Subject: Revised 2024 Integrated Groundwater Monitoring Report
Study Areas 5, 6 & 7

REVISED 2024 INTEGRATED GROUNDWATER MONITORING REPORT
STUDY AREAS 5, 6 & 7

**INTEGRATED ANNUAL GROUNDWATER
PERFORMANCE REPORT
FOR 2024**

**STUDY AREAS 5, 6, AND 7
JERSEY CITY, NEW JERSEY**

Figure
4-10

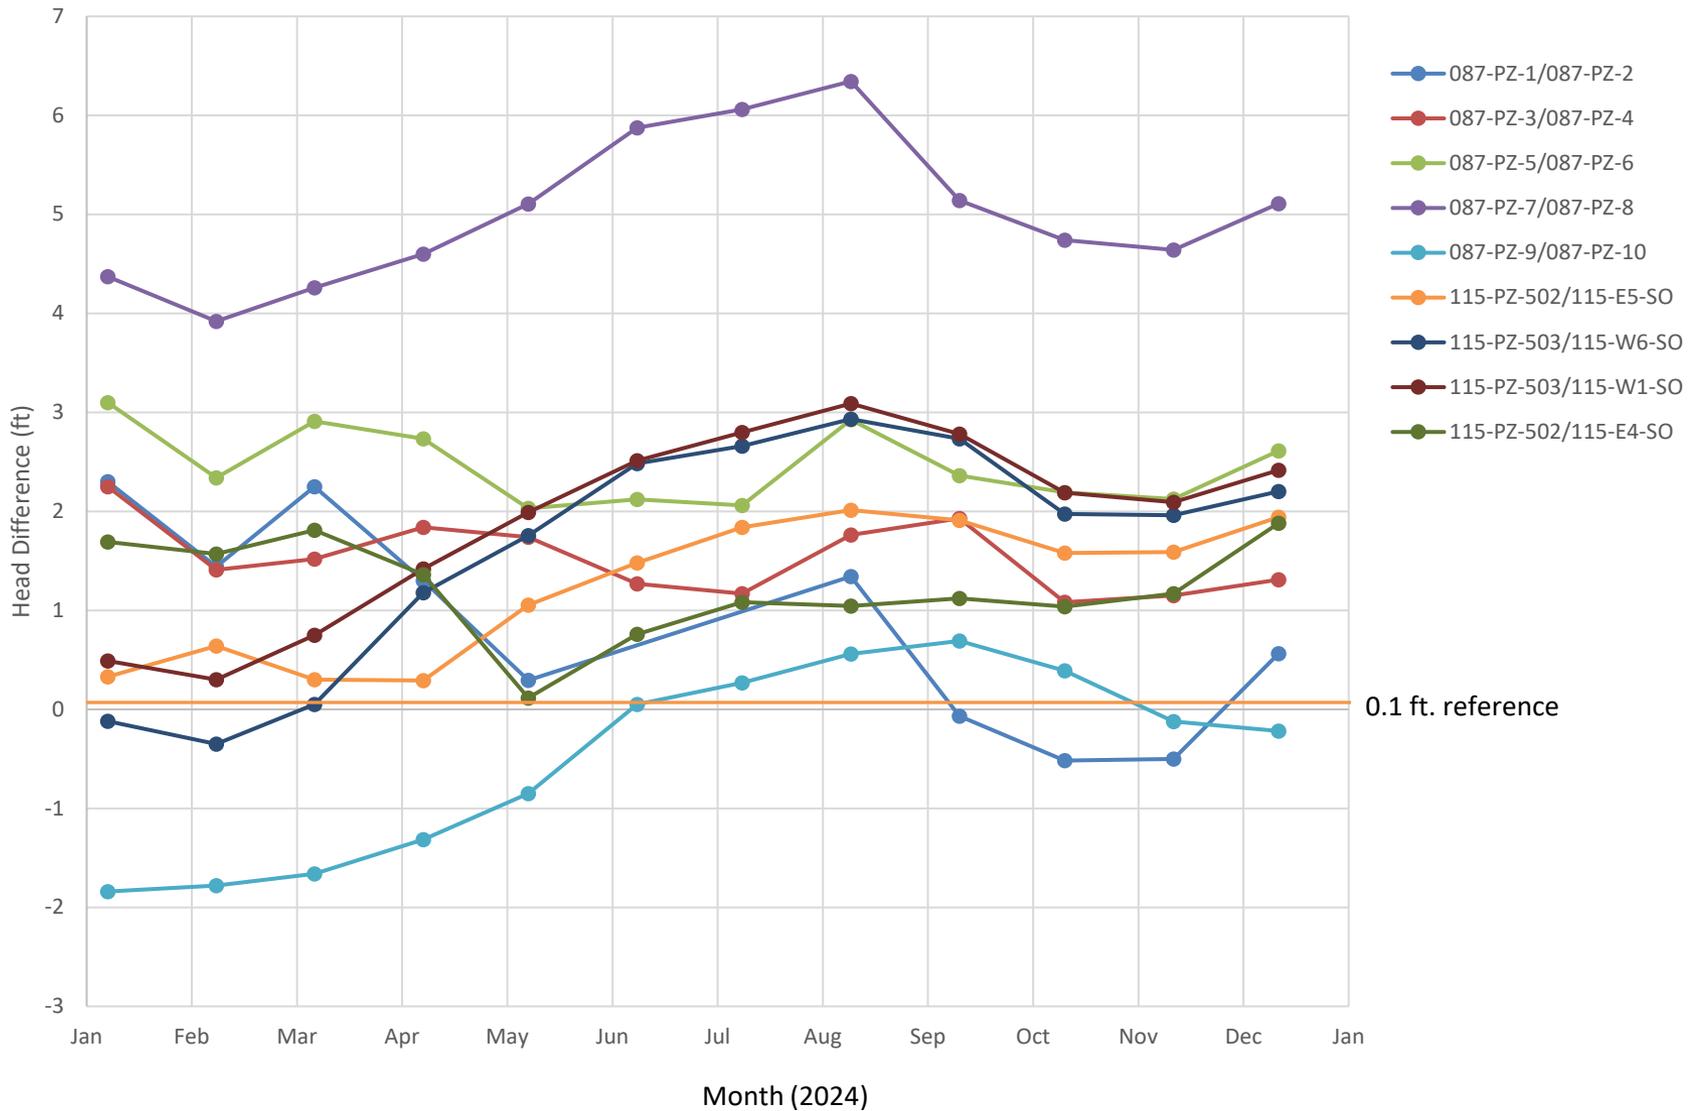
- The Revised 2024 IGWMR includes a revised Figure 4-10 which graphs the head differences across the NJCU hydraulic barrier wall.
- The Revised 2024 IGWMR includes revised Figures 4-11 and 4-12 which graph the head differences across the SA-6 North and SA-6 South hydraulic barrier walls, respectively.
